PERIMETER SECURITY IMPROVEMENTS

UNITED STATES DEPARTMENT OF STATE
HARRY S TRUMAN BUILDING

Final Submission for NCPC Approval

- Drawing 2.01 Vicinity Map
- Document 2.02 NCPC Comments on the 65% Set of Construction Documents with DOS Responses

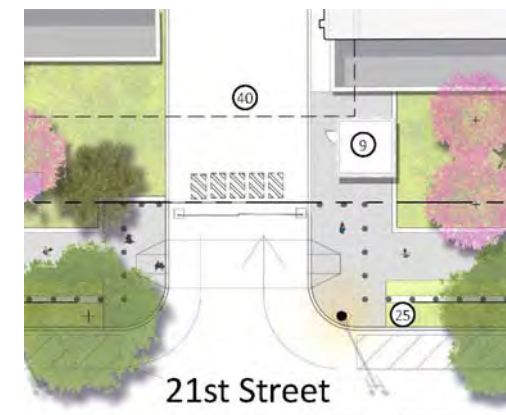
NCPC 65% Review Comment: The following comment refers to specific conditions along 21st Street on each side of the parking loading entrance; refer to *Landscape Layout Plan 21st Street* (Sheet L-125). We recognize that aligning bollards in both directions with the existing granite coping along the building yard is not feasible due to security and circulation constraints. We encourage the design team to look for opportunities to minimize the number of bollards and provide a more graceful transition with the existing architecture features where possible.

DOS Response to 65% Review Comment (May 5, 2016): Similar to the use of shallow foundation bollards for increasing tree soil volume, DOS is investigating alternative barrier structures that will maximize the clear distance in support of pedestrian flow. To date, we haven't identified an alternative that improves the shown clearances, but we will continue to explore opportunities and brainstorm for bollard configurations that encourage the stated goal of a graceful transition with existing architecture.

DOS Update based on the July 7, 2016 CFA Submission for Final Approval:

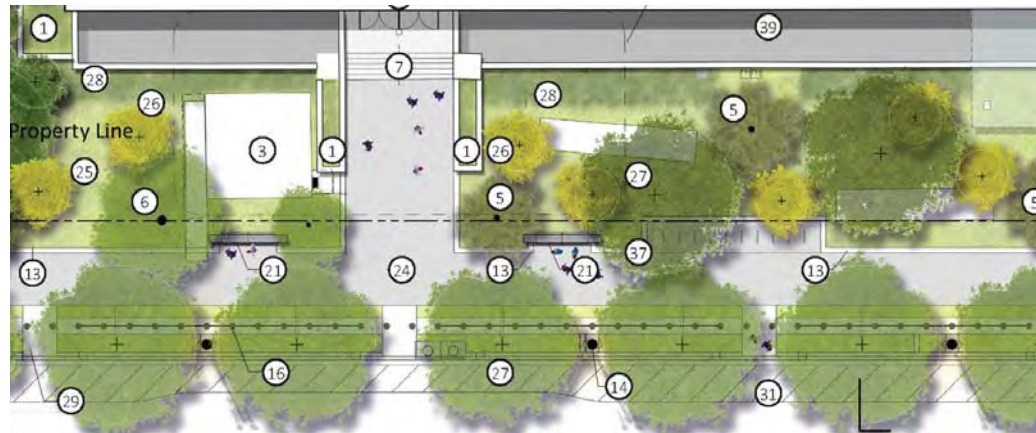
NCPC 65% Review Comment: The latest drawings do not show additional seating opportunities outside the jogger's entrance; refer to enlarged plan along C Street East, *Landscape Layout Plan* (Sheet L-124). NCPC staff recommends to explore seating opportunities in this area to benefit DOS employees as well as pedestrians walking along 21st Street.

DOS Response to 65% Review Comment (May 5, 2016): In drawing 5.36 (Amenity Diagram – Benches) dated 28 August 2015 in the NCPC Preliminary Submission, DOS had identified 602 feet of bench material that could support an occupancy of 297 people. Revisions have been made at the following locations to increase the bench count to 612 feet (or a 302 person occupancy).

The Final Submission includes two (2) seat walls with benches that flank both sides of the 21st Street Jogger's Entrance and a reconfigured bike rack that required an adjustment to deconflict with underground storage fuel tanks just to the north. The diagram below was cropped from drawing 5.06 (CFA Submission for Final Approval).

POCKET PARK @ D STREET
Scale: 1/16"=1'-0"

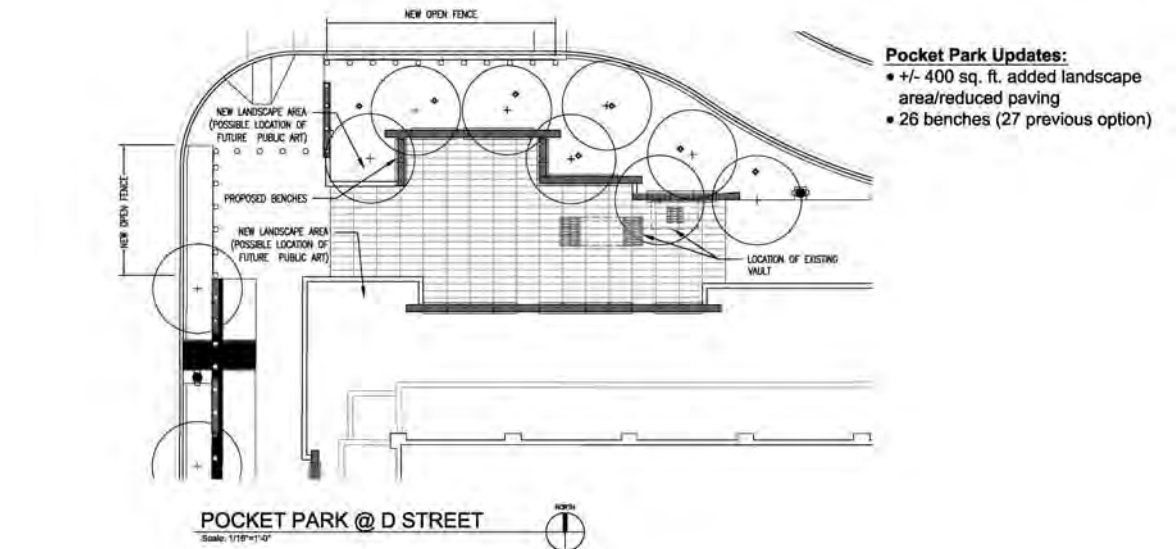
NCPC 65% Review Comment: We recommend considering more landscape areas and amenities to ensure that the pocket park is attractive, inviting and welcoming. Amenities may include exhibit areas for rotating art installations to showcase the foreign mission of the agency. We would like to have a better sense of the direction and plans for the park design prior to construction and at final review. While a sculptural element may come later, the scale, location and configuration of the major permanent elements, such as seating, landscaping and open spaces, should be presented at final.

DOS Response to 65% Review Comment (May 5, 2016): Drawing L-117 (Materials and Hardscape – D Street) and drawing L-127 (Landscape Layout Plan – D Street) are accurate reflections of the balance between hardscape and landscape that DOS is trying to accomplish at this significant pedestrian intersection. As it is public space, DOS has looked to DCOP and DDOT for guidance, and developed the identified treatments to include paving materials, street trees, and site furnishings according to District standards. A fully-detailed drawing L-147 (Landscape Planting Plan – D Street) will be submitted with the NCPC Final Submission in order to inform how DOS intends, through the use of specific shrubs, perennial, and annual plantings, to make this space as attractive, inviting, and welcoming as possible. The design team has studied the pocket park to determine if slightly more planting area can be added without compromising pedestrian flow, and is proposing the following modification to hardscape and landscape.

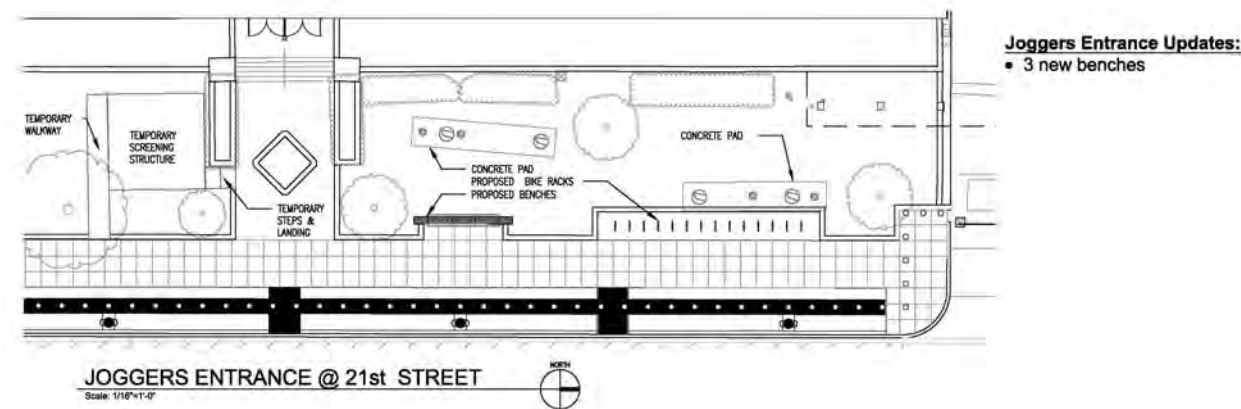
Given that the pedestrian traffic will be coming mostly from the north along 23rd Street (Foggy Bottom Metro Station), and the opening of D Street will encourage east-west pedestrian circulation; staff recommends making the park visually and physically accessible.

The *Layout Landscape Plan D Street* (Sheet L-127) shows an additional perpendicular bench on a plinth wall, staff recommends to refine the transition and details between the benches and the plinth walls at the 90 degree intersection to create a flush condition and minimize obstructions and interruption of pedestrian circulation along the park.

DOS Response to 65% Review Comment (May 5, 2016): DOS agreed with the NCPC recommendation that replacing the bike rack with bench seating at the pocket park minimizes the clutter and improves efficiency. Bicycle storage activities are better served in a location that is closer to building entrances and away from pedestrian intersections. The pocket park rendering (Drawing 5.19 – 23rd Street visualization – Pocket Park) will be revised to reflect this change as shown in the 65% CDs.
